Access Compliance Report

Public Rights-of-Way

(Curb Ramps)

Intersection ID: 18202	Main Street: CLOVER_RD	Cross Street: S_SHARON_AMITY_RD	Location: S
ADA ID: C03AFDE7198C	Ramp Type: PerpDiag	Initial Pass/Fail: Fail	Overall Compliance: No
Severity Score: 37.5			
Codes/Mitigation Info/Possible Solution		Field Measurements/Component Compliance

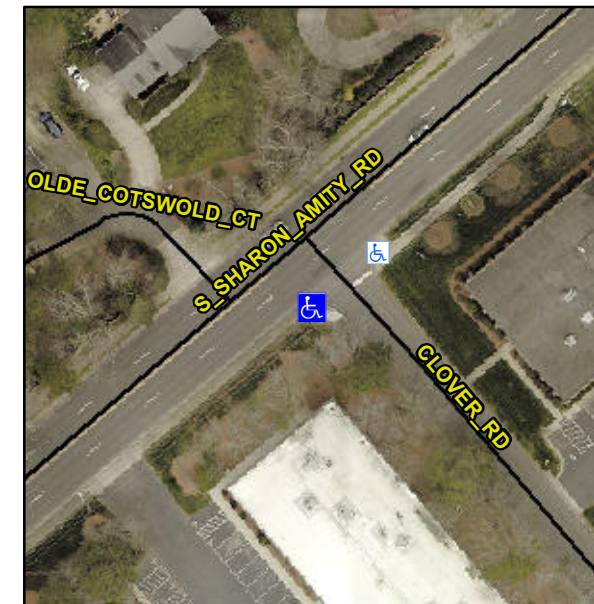
Not Found, R304.2.2, R304.5.3

Compliance	Description	Data	Compliance	Description	Data
N/A	Ramp Length (in)	96.0	No	Ramp Slope (%)	10.8
Yes	Ramp Width (in)	48.0	No	Ramp XSlope (%)	7.0
N/A	Flare Type LT	N/A	N/A	Flare Type RT	N/A
N/A	Flare Slope LT (%)	N/A	N/A	Flare Slope RT (%)	N/A
N/A	Flare Traversable LT?	N/A	N/A	Flare Traversable RT?	N/A
N/A	Landing Length (in)	N/A	N/A	DWS Provided?	N/A
N/A	Landing Width (in)	N/A	N/A	DWS Contrast?	N/A
N/A	Landing Slope (%)	N/A	N/A	DWS Length (in)	N/A
N/A	Landing X Slope (%)	N/A	N/A	DWS Full Width?	N/A
N/A	Landing Curb? (Y/N)	N/A	N/A	DWS Offset (in)	N/A
N/A	Shared Landing?	N/A			
N/A	Gutter Ponding?	N/A	N/A	Gutter Slope (%)	N/A
N/A	Gutter Lip Ht (in)	N/A	N/A	Gutter X Slope (%)	N/A
N/A	Painted X Walk1?	No	N/A	Painted X Walk2?	No
	X Walk 1 Direction	To NE		X Walk 2 Direction	To NW
N/A	X Walk 1 Width (in)	N/A	N/A	X Walk 2 Width (in)	N/A
	X Walk 1 Slope (%)	6.5		X Walk 2 Slope (%)	3.0
	X Walk 1 X Slope (%)	1.4		X Walk 2 X Slope (%)	2.9

Remove & Replace Curb Ramp With Two New Directional Ramps or Equivalent.
